**Response to
Request for Additional Information No. 416(4767, 4749), Revision 1
Supplement 1**

**U.S. EPR Standard Design Certification
AREVA NP Inc.
Docket No. 52-020
SRP Section: 06.02.01 - Containment Functional Design
SRP Section: 06.03 - Emergency Core Cooling System**

Application Section: FSAR Chapter 6

Figure 06.02.01-95-1—Local Vapor Temperatures in Affected Nodes for Limiting CLPS LOCA

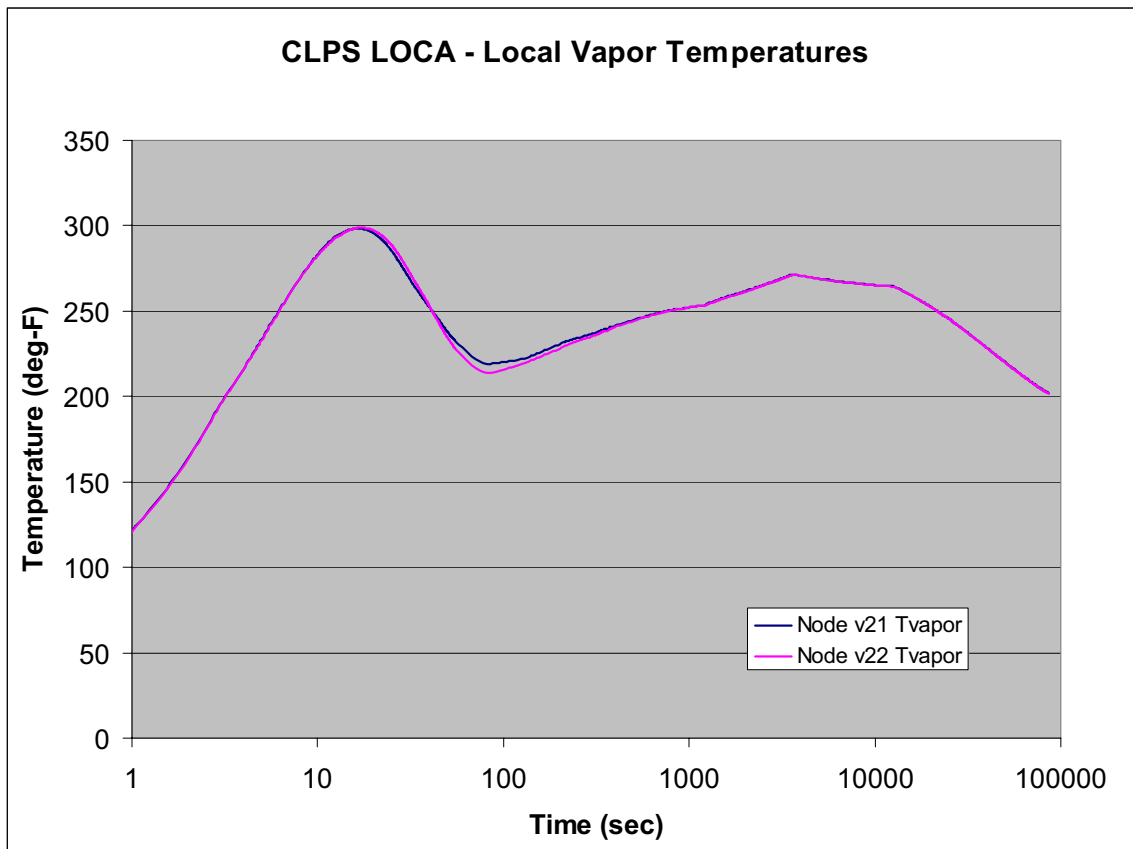
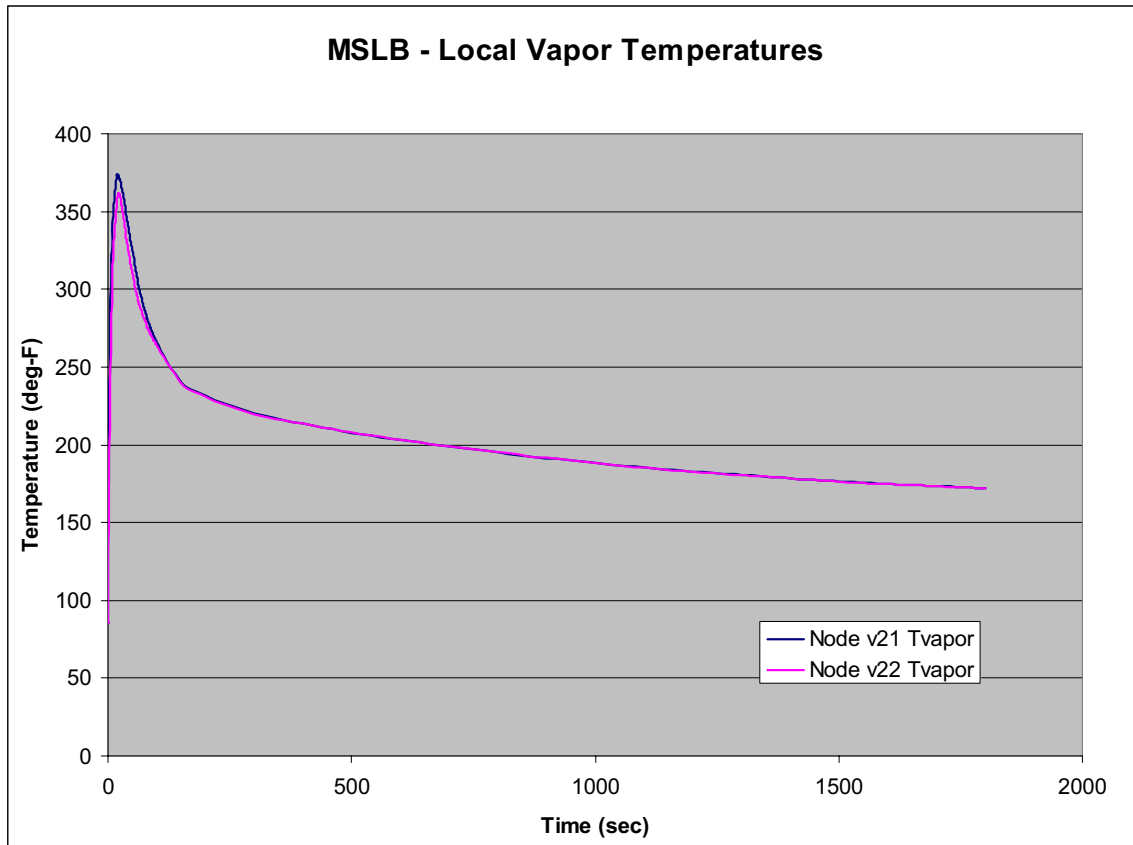
In letter dated 12/10/2009 in response to RAI No. 266 Supplement 2, the applicant provided Gothic input decks. In a review of the GOTHIC input tables (Thermal Conductors) generated at the NRC from file "clps_np_s_sd2, Oct/27/2009", it was noted that containment liner wall areas between cells v21 and v22 showed significant skewing (12280 vs. 15067.8 ft²). Please verify that this skewed set of liner areas are currently being used in AVEVA Chapter 6 calculations. Discuss the reason for the skewing and whether these area values are correct. If not correct, provide a corrected set of v21/v22 liner areas and discuss the impact this error may have on containment pressure, local (v21 and v22) gas and liner temperatures.

Figures 06.02.01-95-1 and 06.02.01-95-2 show, for the limiting CLPS LOCA and MSLB, respectively, the skewed heat sink surface areas have an insignificant impact on the local temperature response of the affected nodes. There will be an insignificant impact on the surface temperatures of the affected liners (GOTHIC heat structures #3 and #4) because they are exposed to similar magnitude gas temperatures, as shown in Figures 06.02.01-95-1 and 06.02.01-95-2.
